# LOT 10 PARKER POINTE

LOT 10, PARKER POINTE FILING NO. 1  
 A PART SECTION 3, TOWNSHIP 7 SOUTH, RANGE 66 WEST OF THE SIXTH PRINCIPAL MERIDIAN  
 TOWN OF PARKER, COUNTY OF DOUGLAS, STATE OF COLORADO

## SITE PLAN

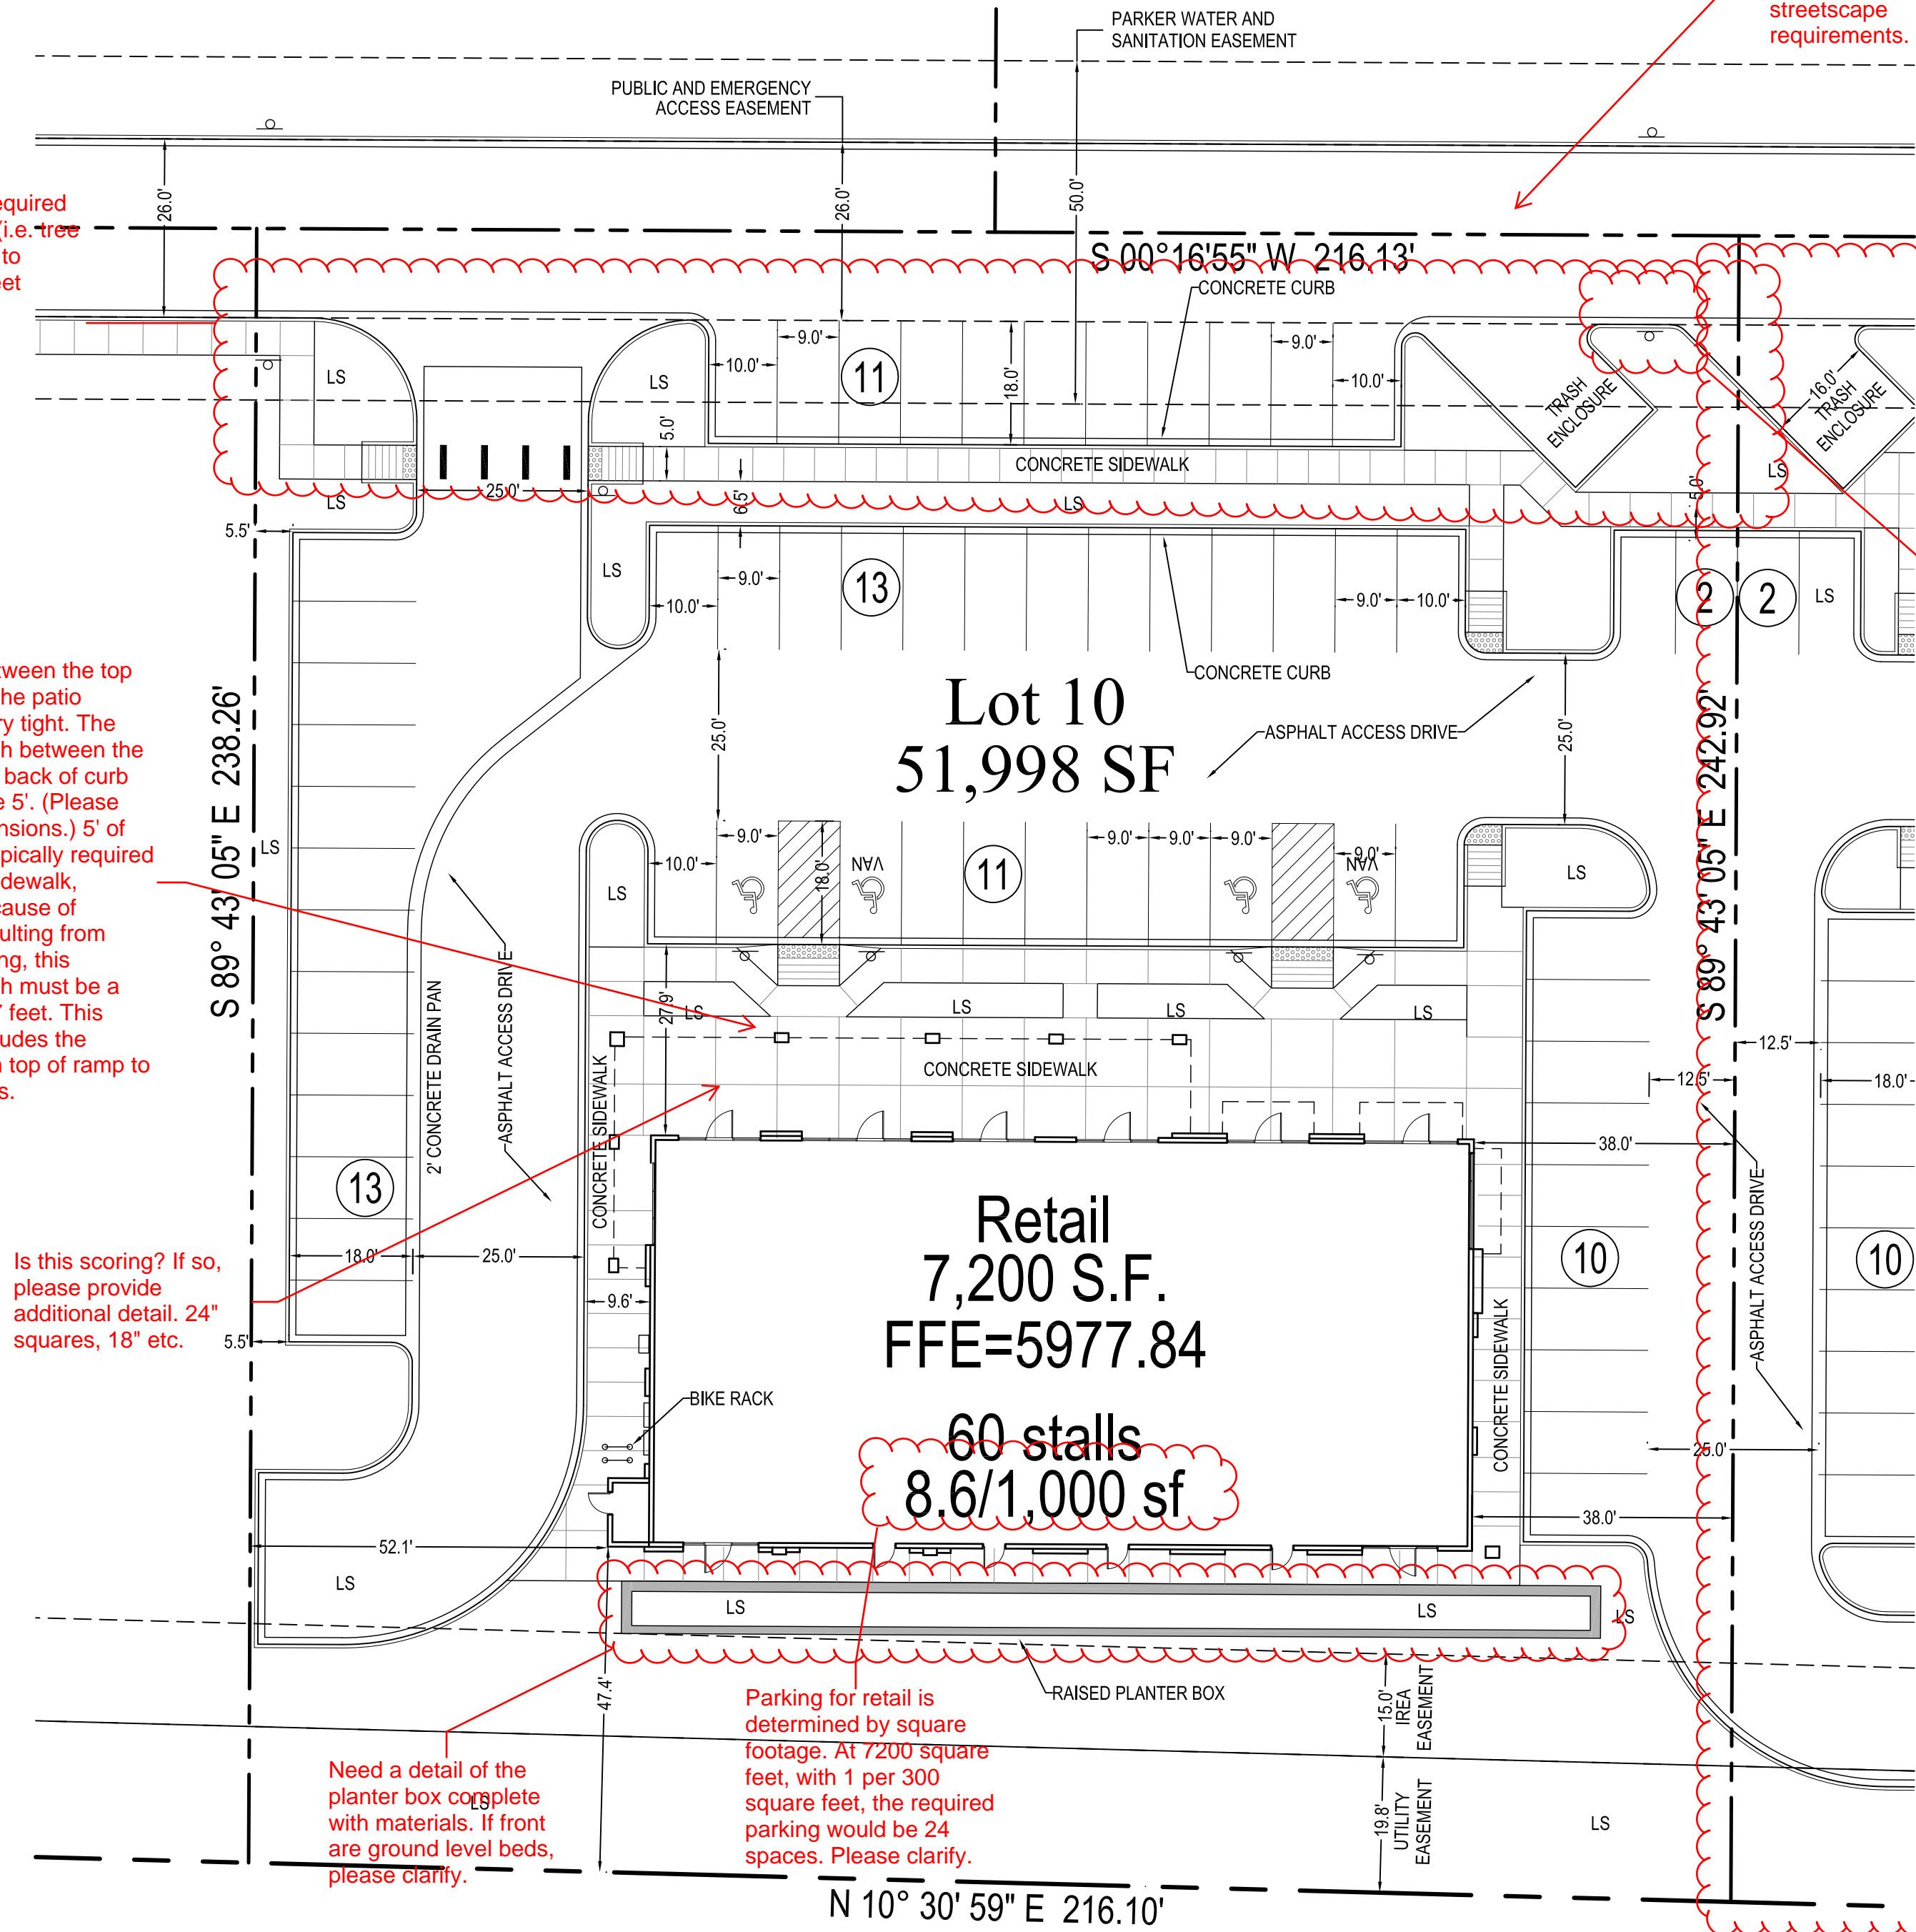
General site plan submittal requirements  
 Need gross, lot and net acreage for proposed use/site.  
 Need building dimensions.  
 Add names of adjacent streets  
 Exterior lighting locations and fixture types are not shown as required.  
 Show direction of travel on for access aisles and driveways.  
 Identify adjacent lots.

Per CI&MF  
 Need sidewalk connection to Parker Rd sidewalk. May use a single connection for lots 9 and 10, but connection is required to ultimately tie into Lemon Gulch trail.

This area needs to be redesigned to include required street scape elements. (i.e. tree lawn sidewalk etc.) and to conform to a typical street frontage.

The area between the top of ramp and the patio support is very tight. The sidewalk width between the patio and the back of curb appears to be 5'. (Please provide dimensions.) 5' of sidewalk is typically required for building sidewalk, however, because of overhang resulting from head in parking, this sidewalk width must be a minimum of 7 feet. This minimum includes the distance from top of ramp to patio supports.

Is this scoring? If so, please provide additional detail. 24" squares, 18" etc.

Need a detail of the planter box complete with materials. If front are ground level beds, please clarify.

Parking for retail is determined by square footage. At 7,200 square feet, with 1 per 300 square feet, the required parking would be 24 spaces. Please clarify.

This access aisle needs to look and act like a roadway. Please name it and address streetscape requirements.

Not shown anywhere on the drawing. Please clarify or remove, all sheets.

Staff appreciates the inclusion of sign location, however, signage requires a separate permit and is not approved as a part of the site plan. To avoid confusion please include a note to clarify that the signage is not approved as part of this site plan.

Gray out, not a part of this approved site plan- all sheets. Please verify that this parking is not included on the stated spaces provided. 13.06.050(b) (6) Number of spaces. The total number of parking spaces required shall be the sum of spaces required for the applicable land uses individually, except if the shared parking plan and analysis clearly establish that the shared parking facility can satisfy the demands of all uses with a lesser number of parking spaces.

Not shown on site plan as required.

No proposed easement shown, please clarify or remove.

## UTILITY PLAN

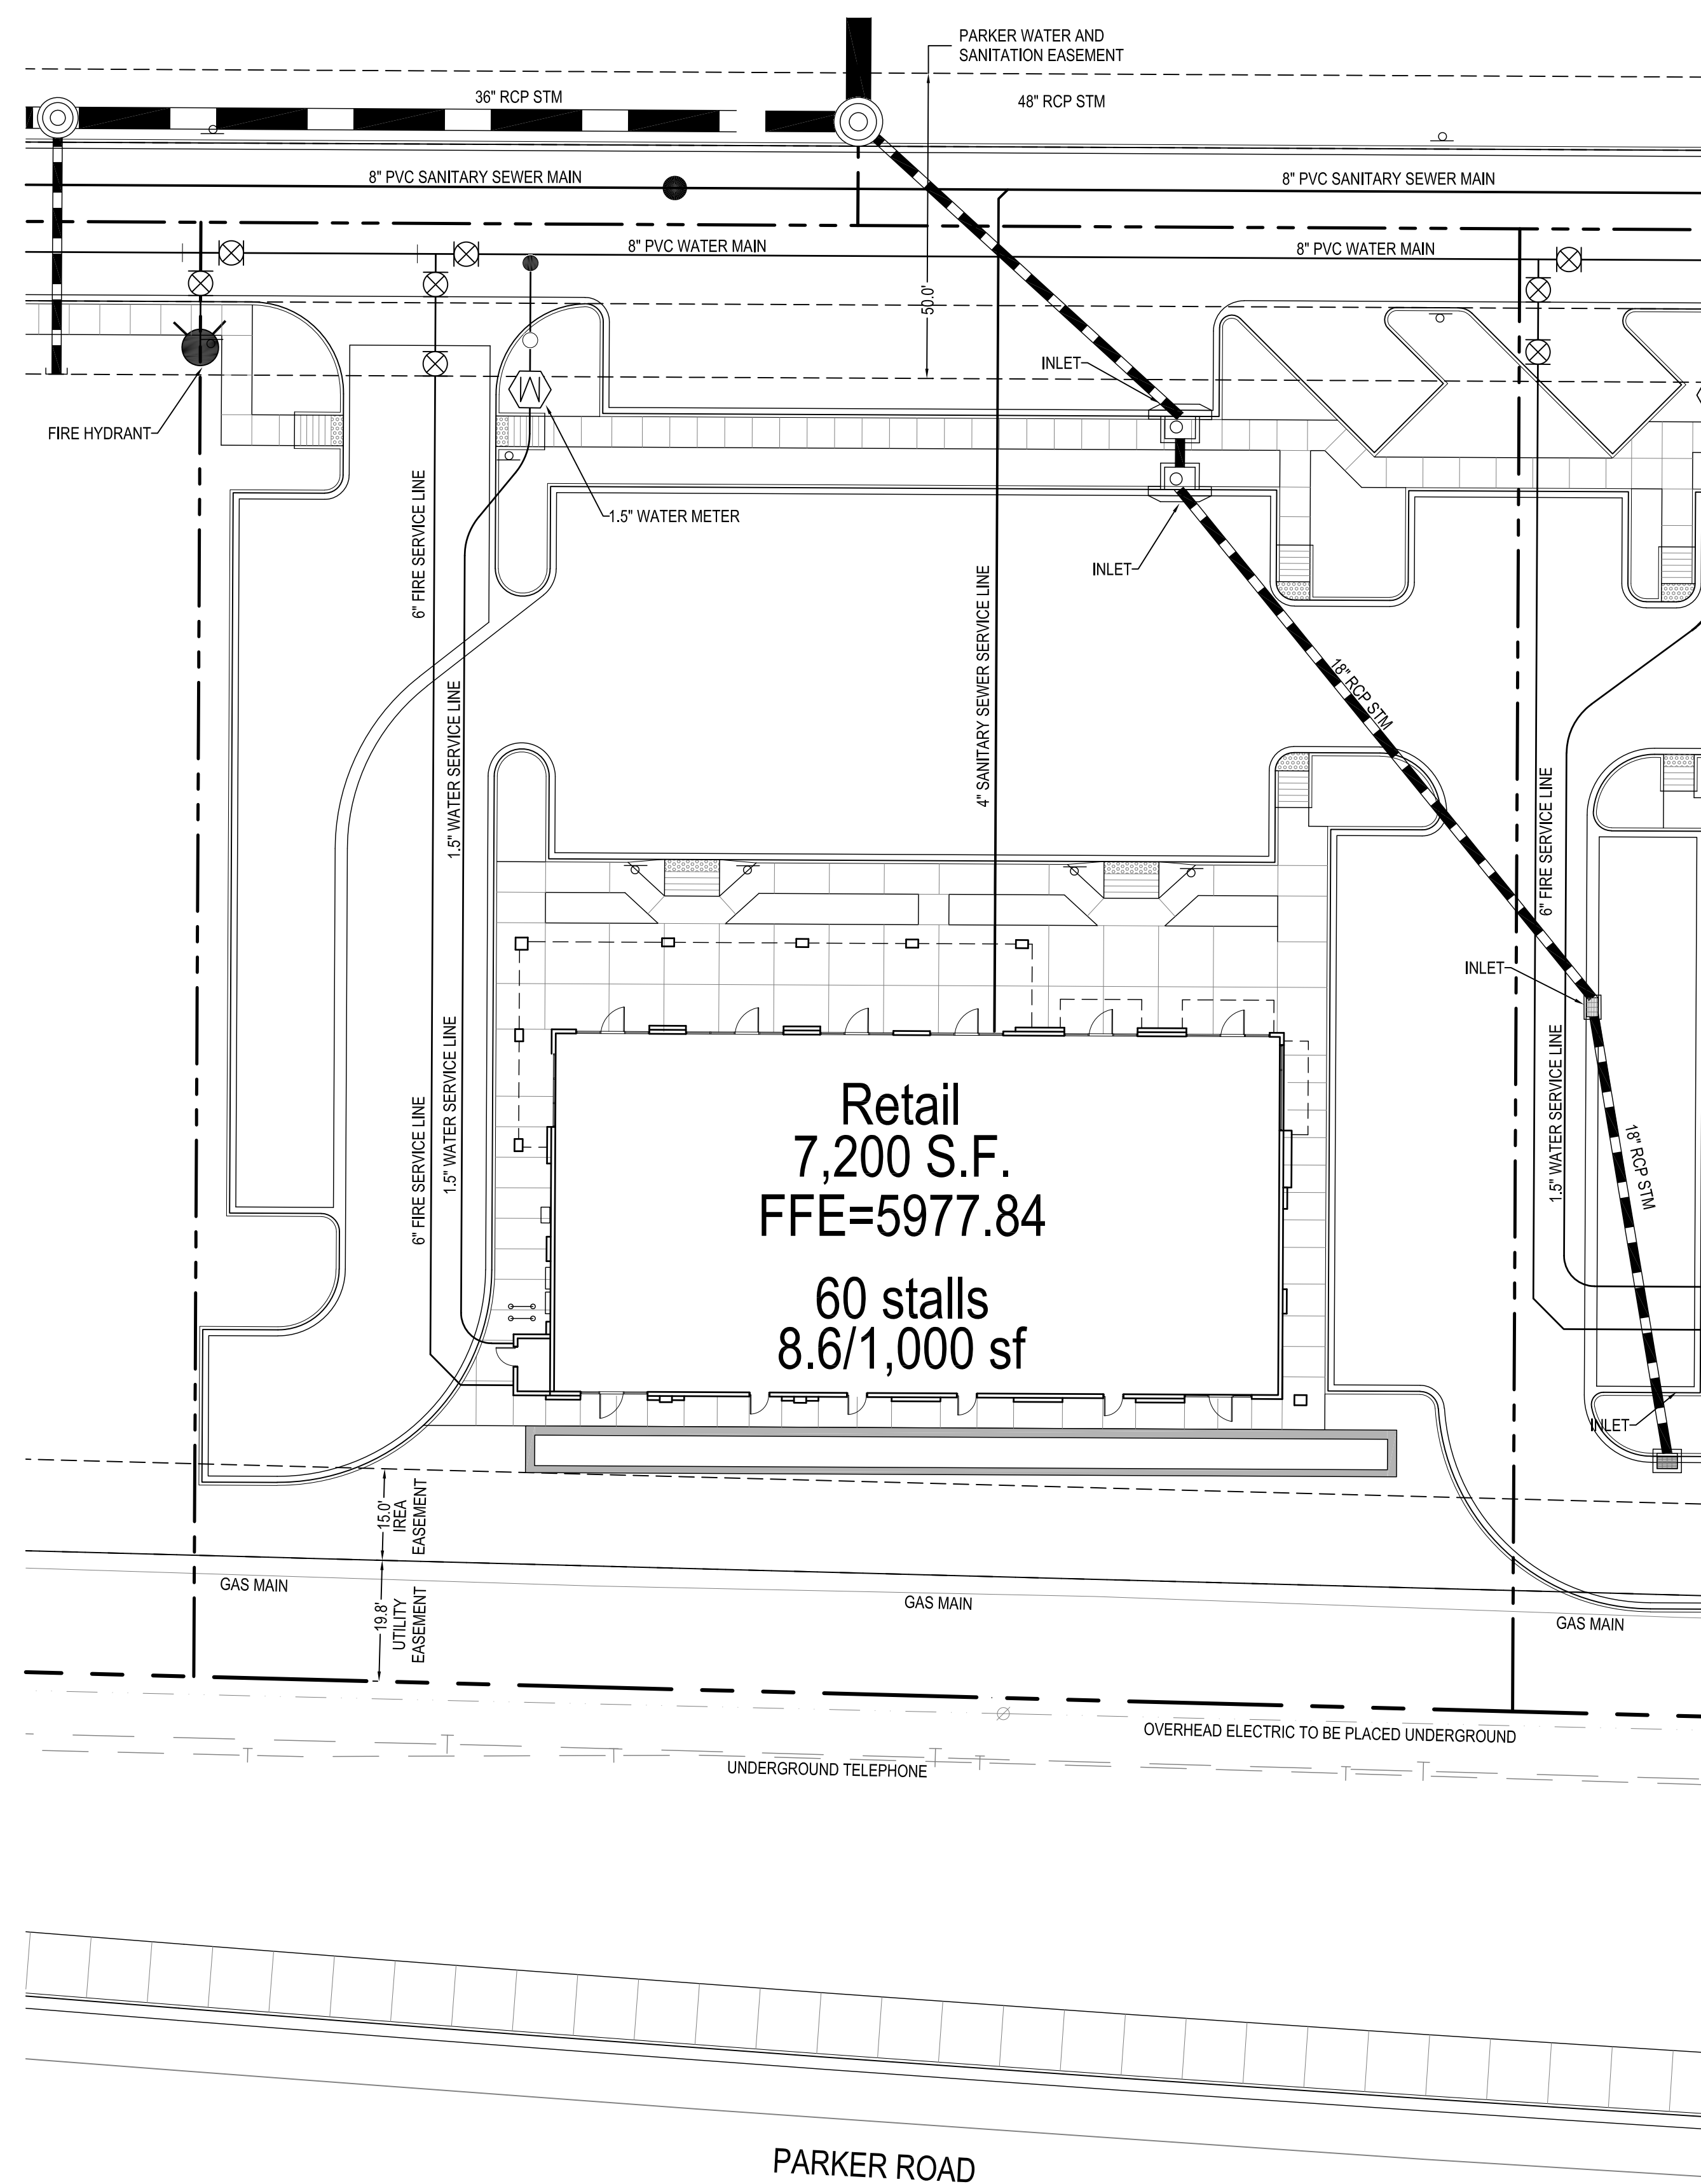
No exterior lighting shown
